Yuba Community College District

No. RFP 22-14

New Softball Field

ADDENDUM NO. 2

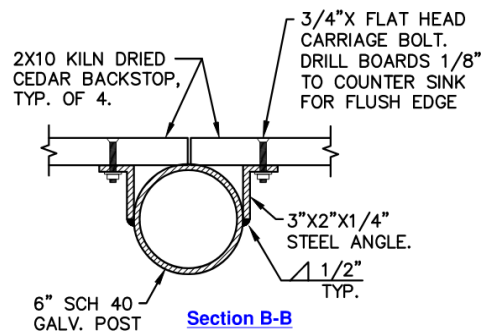
2.20 Question: Provide section B-B as noted. Provide fastener specifications.

Response: Section B-B is the cross section of the post and board attachment shown in the upper right hand corner of the detail. It was not labeled B-B, but this was the intent.

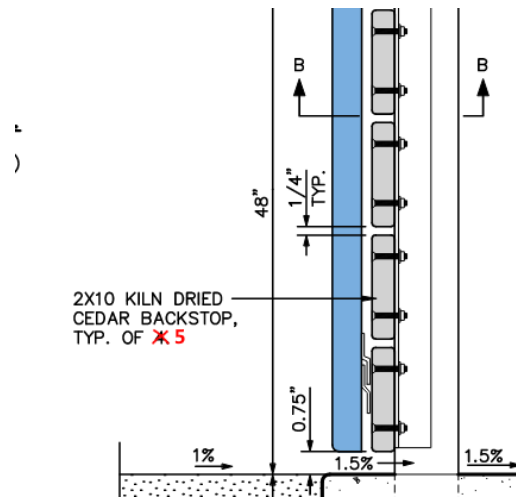
2.21 Question: We have assumed that (5) 2x10 are required. Provide confirmation.

Response: Correct, 5X10'S would be required to get the total height shown, not 4 as indicated in the detail.

Client Project Number:	Client Proj:
Scale:	Sheet
Drawn By: Author	C3.1
Checked By: Checker	
Issue Date: Issue Date	
Revit Version: 2023

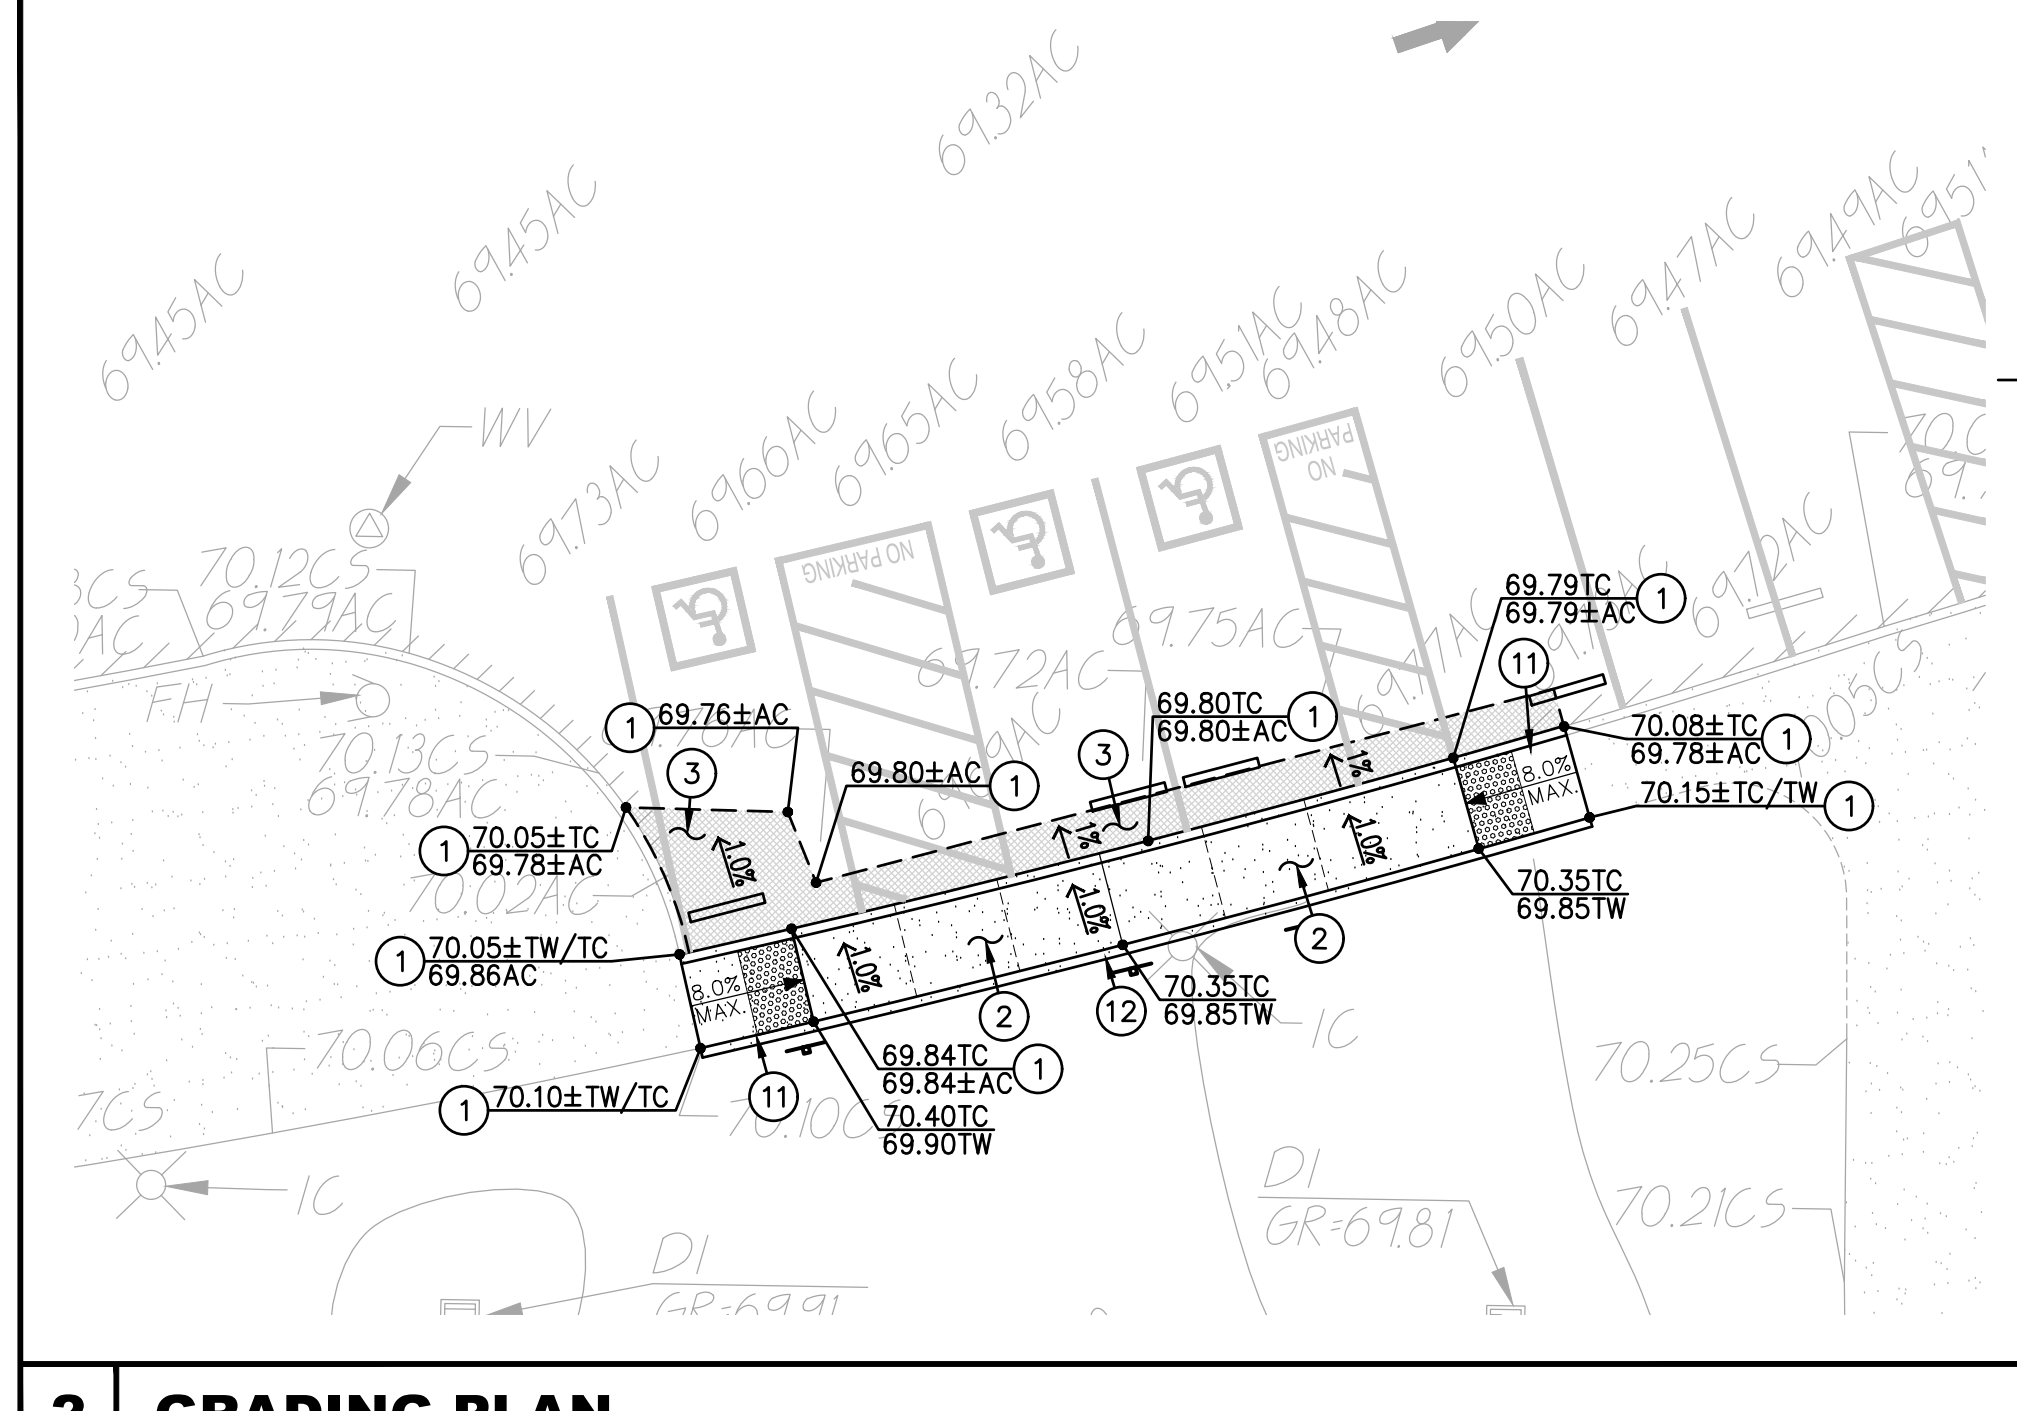
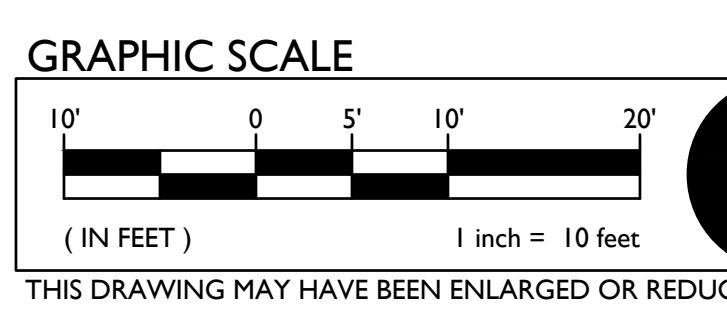
2.6 Refer to Drawing Sheet C3.1

- A. **REVISE** area outside of right field (and between new walkway) to planting area in lieu of decomposed granite. **See attached ‘Sheet C3.1’**

Client Project Number:	Client Proj.
Scale:	Sheet
Drawn By: Author	C3.2
Checked By: Checker	
Issue Date: Issue Date	
Revit Version: 2023	
Sheet	of _____

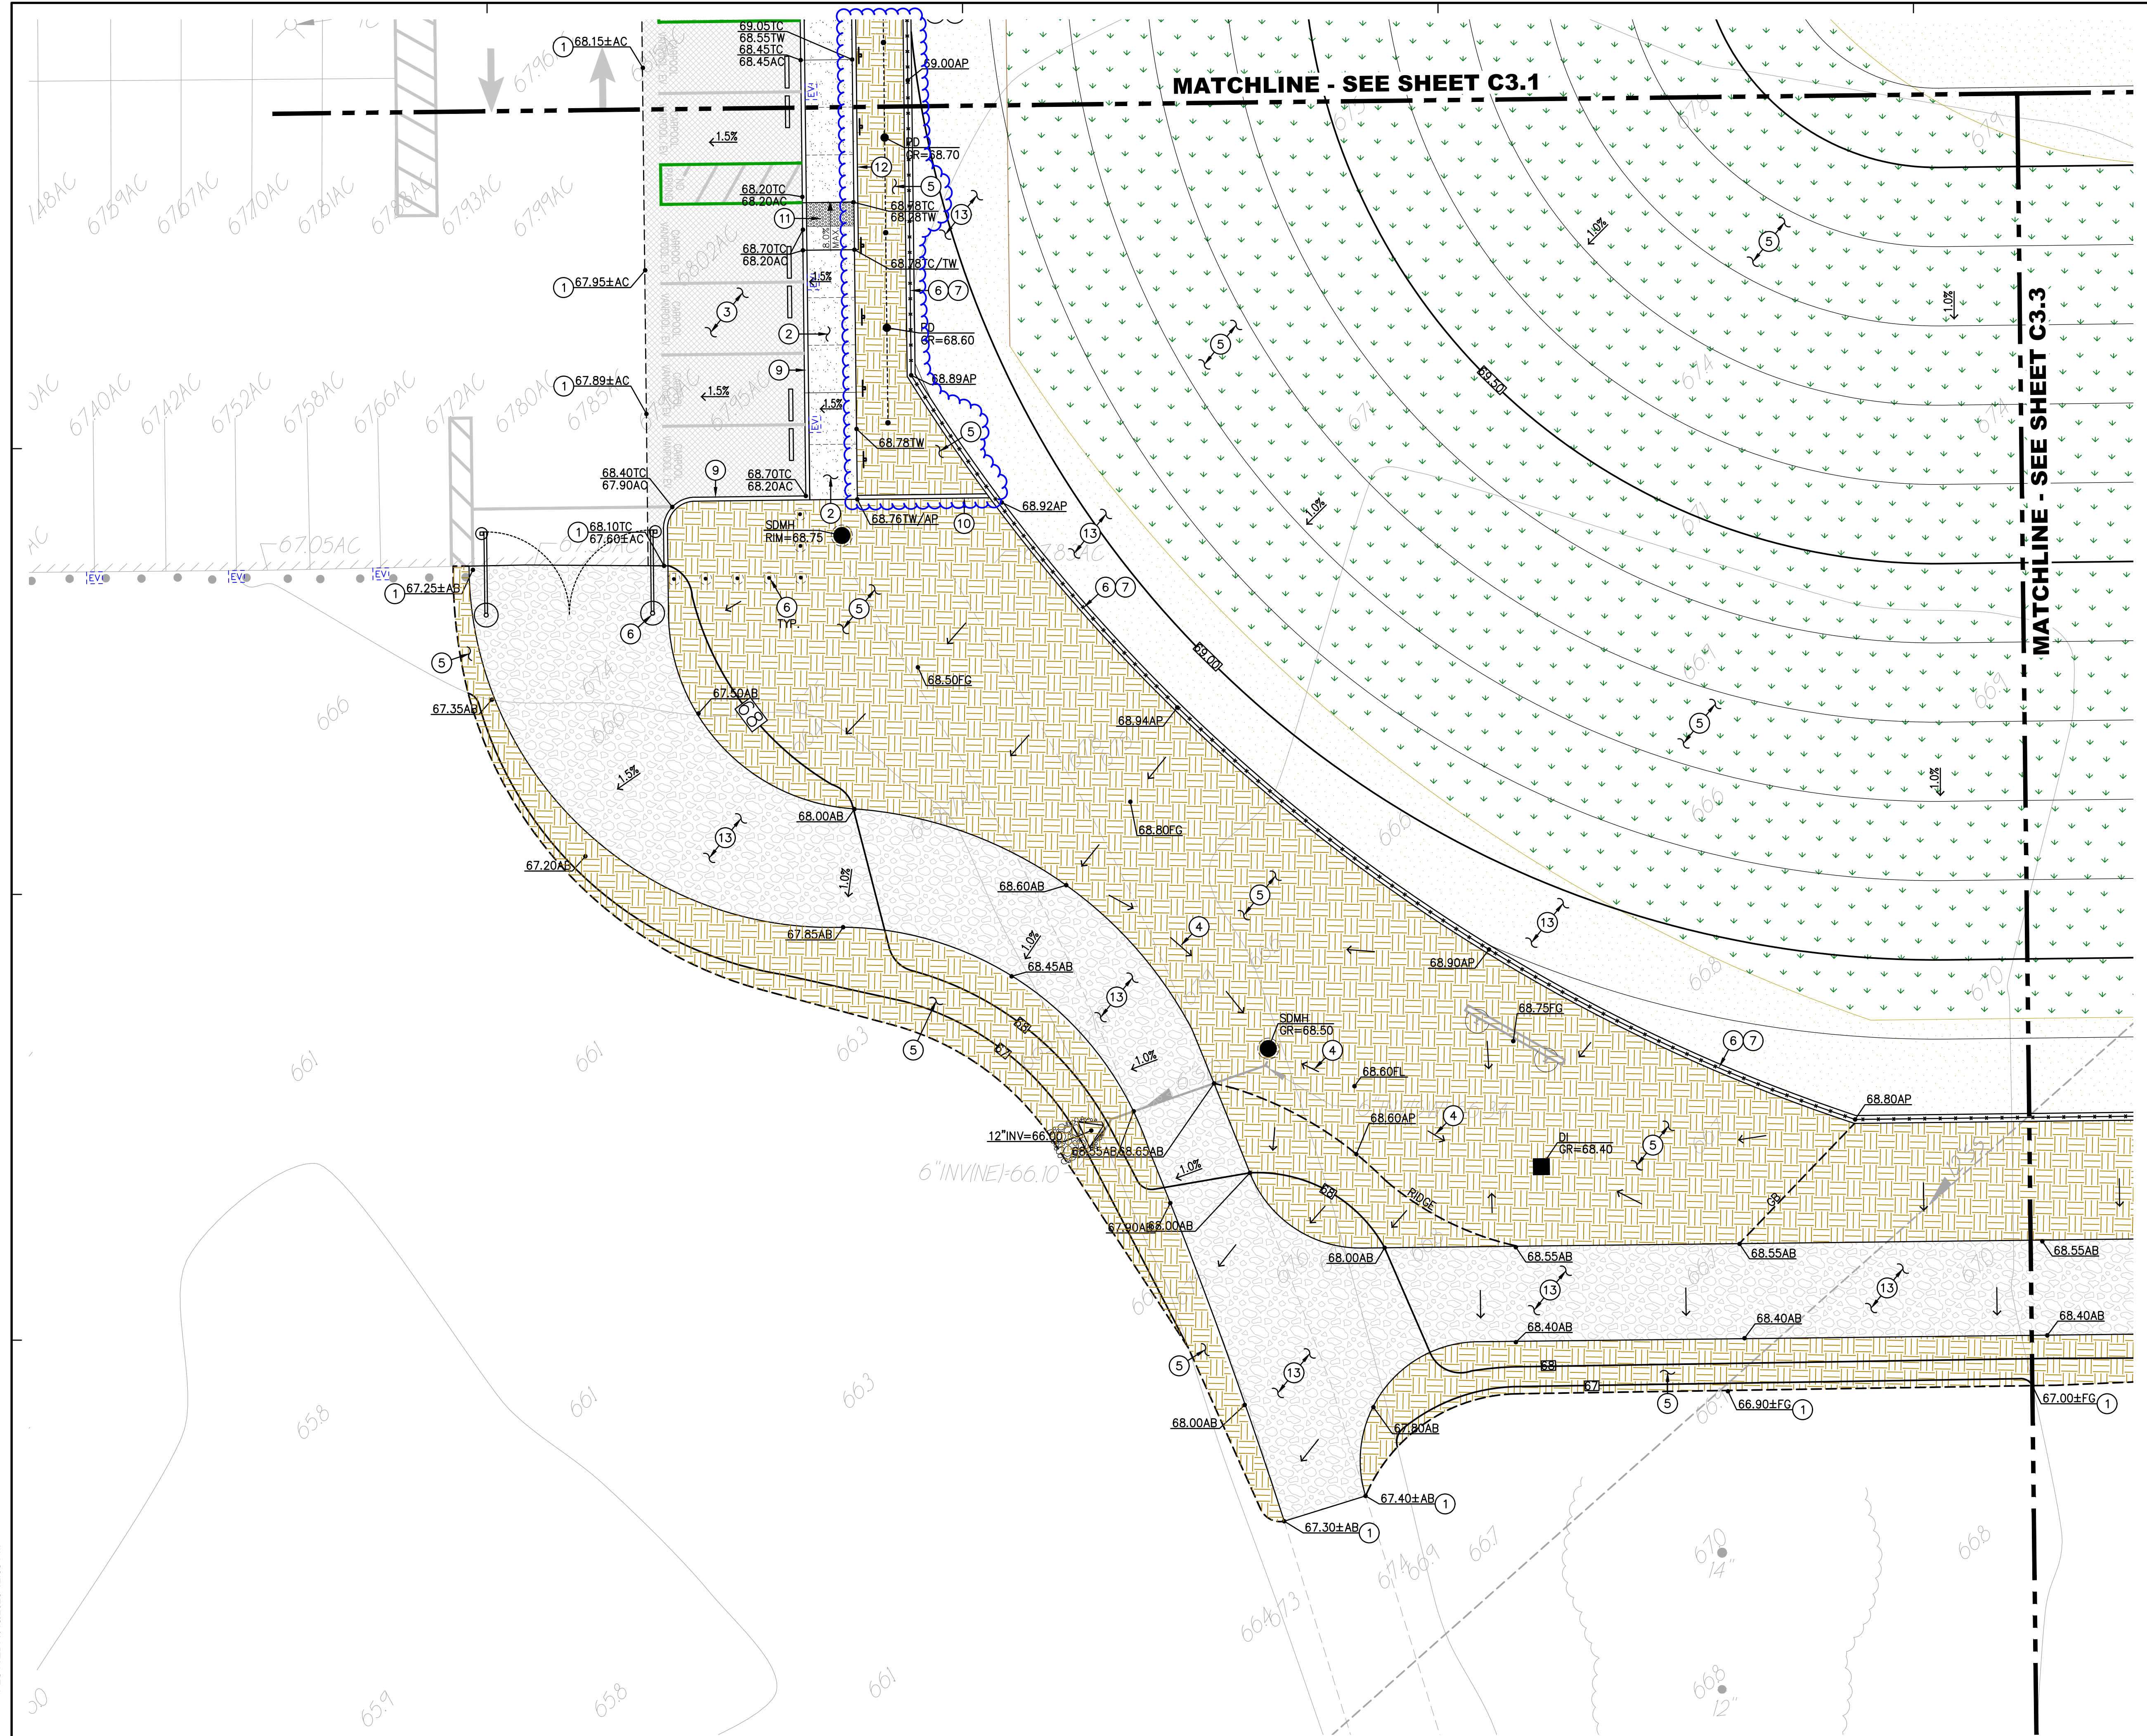
2.7 Refer to Drawing Sheet C3.2

- A. **REVISE** area outside of right field (and between new walkway) to planting area in lieu of decomposed granite. **See attached ‘Sheet C3.2’**

1 PAVING PLAN

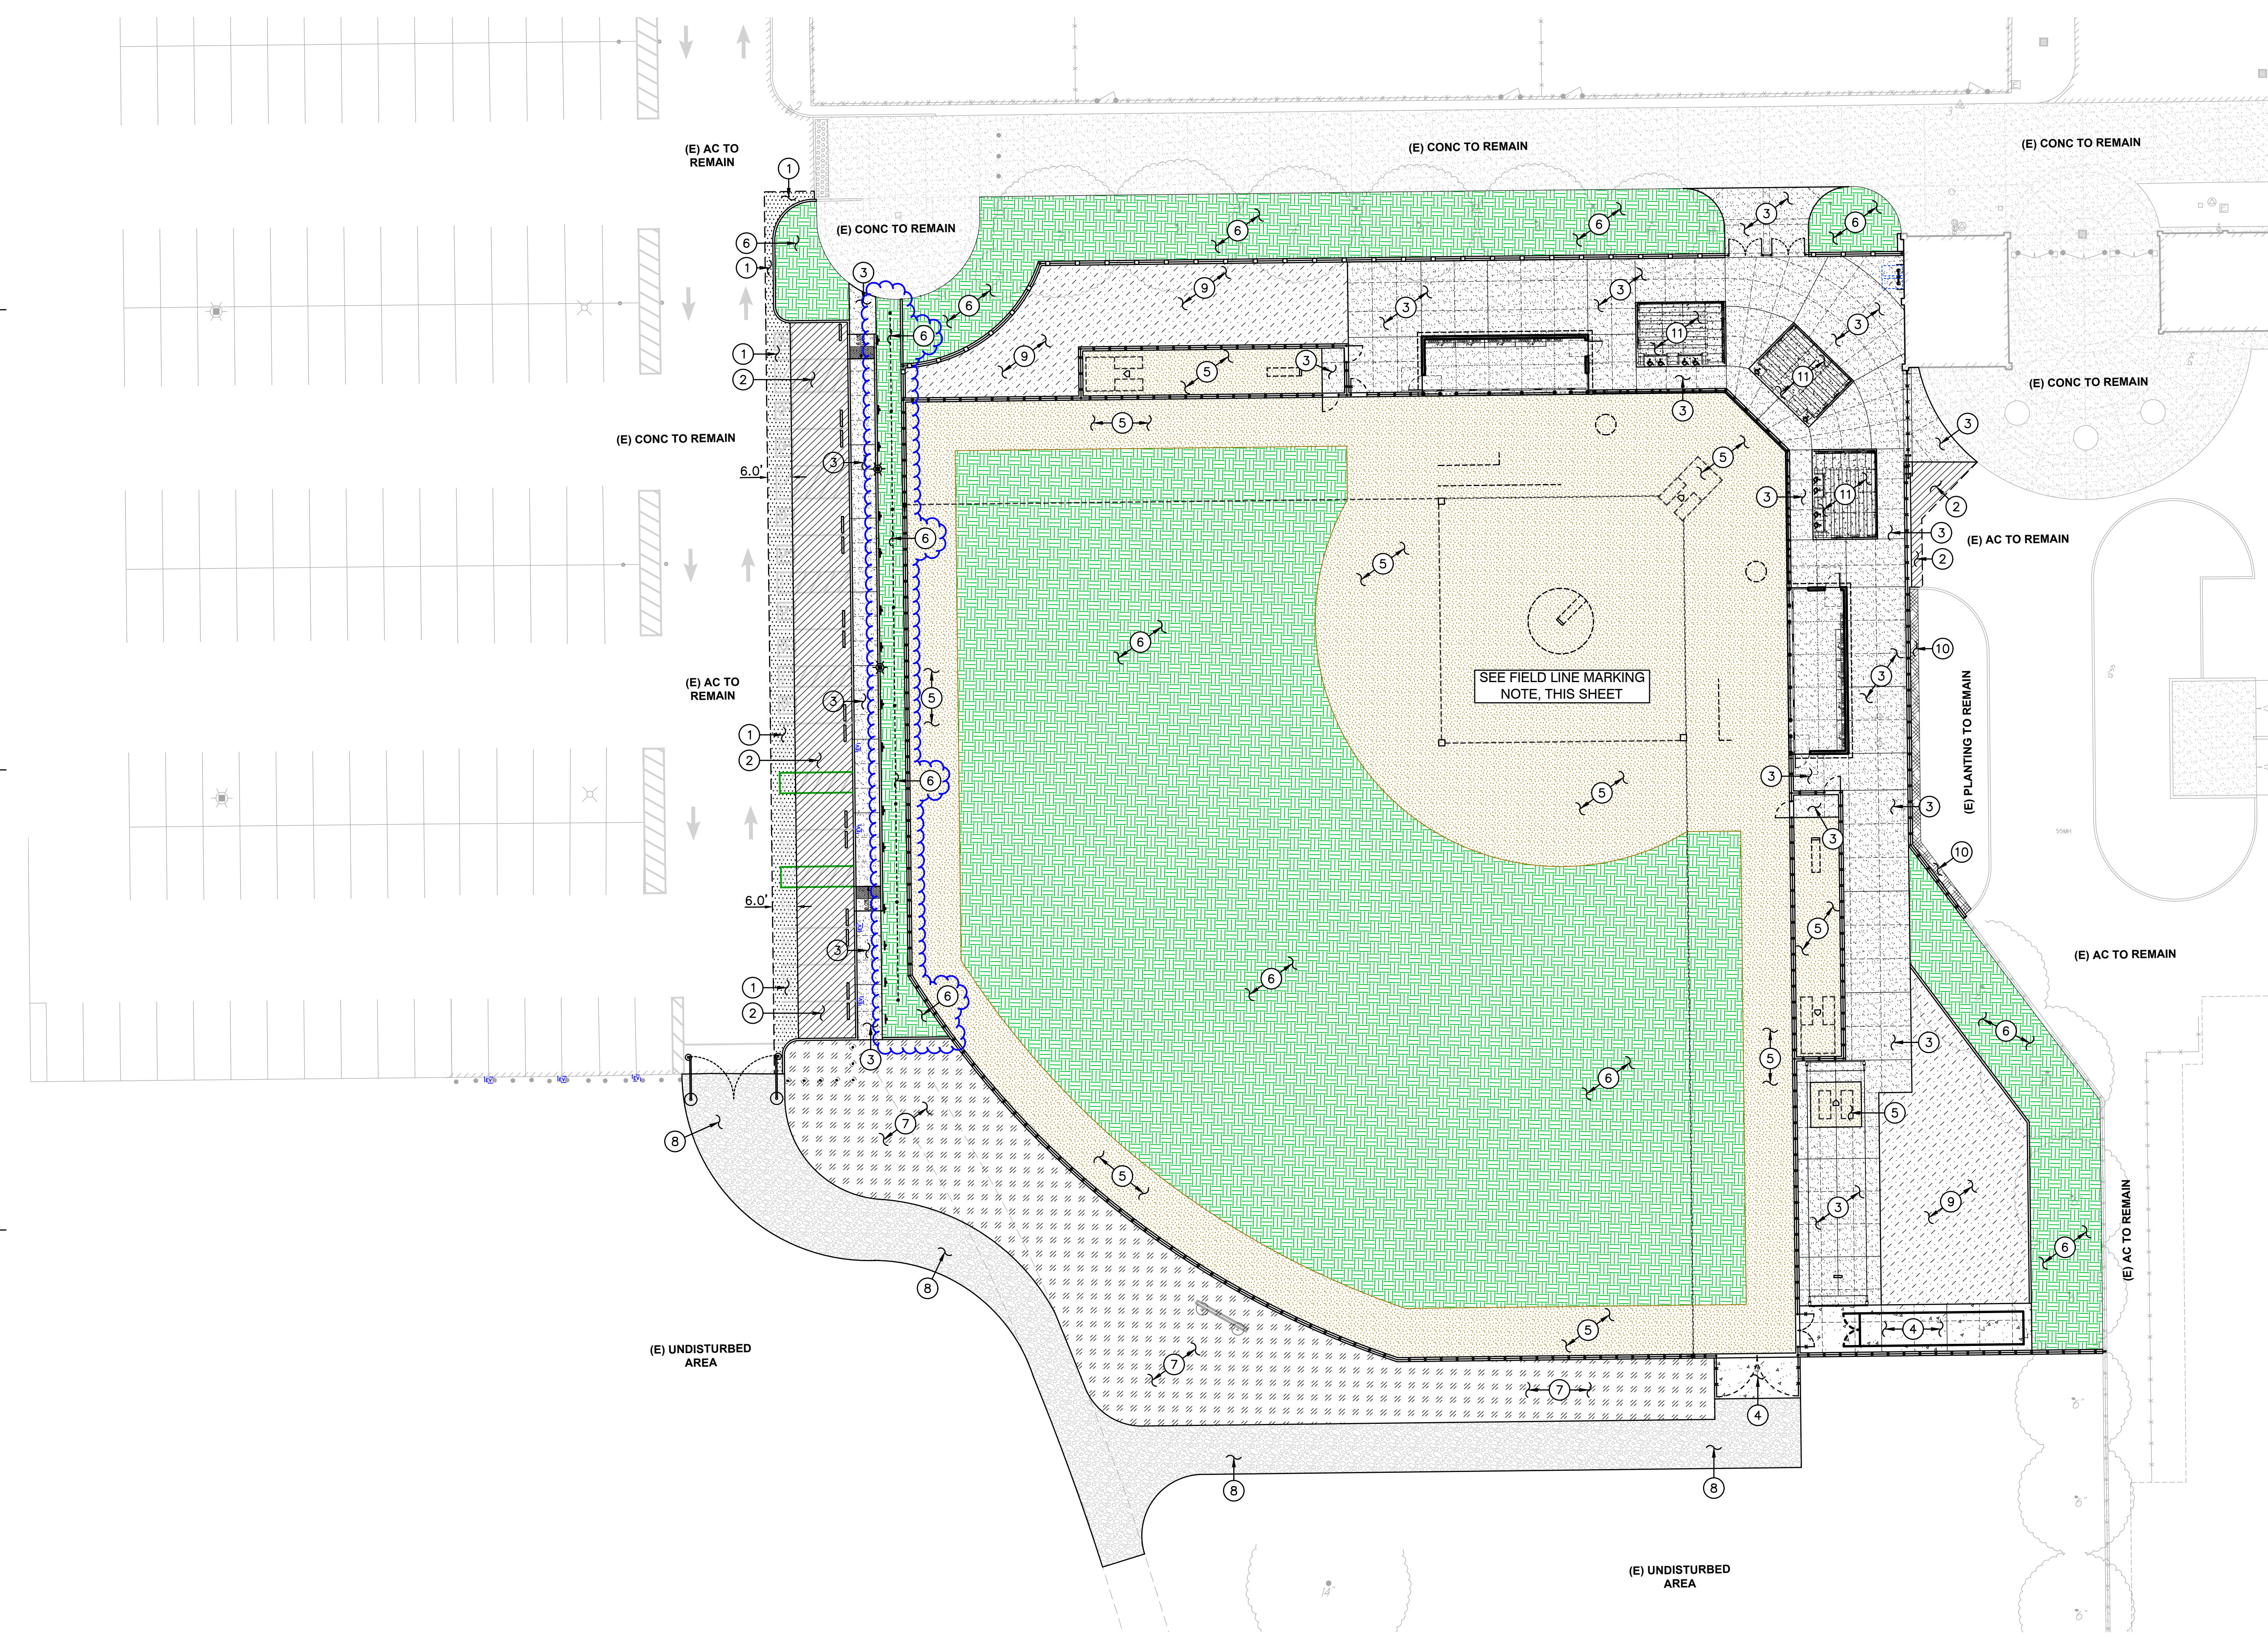
2.8 Refer to Drawing Sheet C5.1

- A. **REVISE** area outside of right field (and between new walkway) to planting area in lieu of decomposed granite. **See attached ‘Sheet C5.1’**
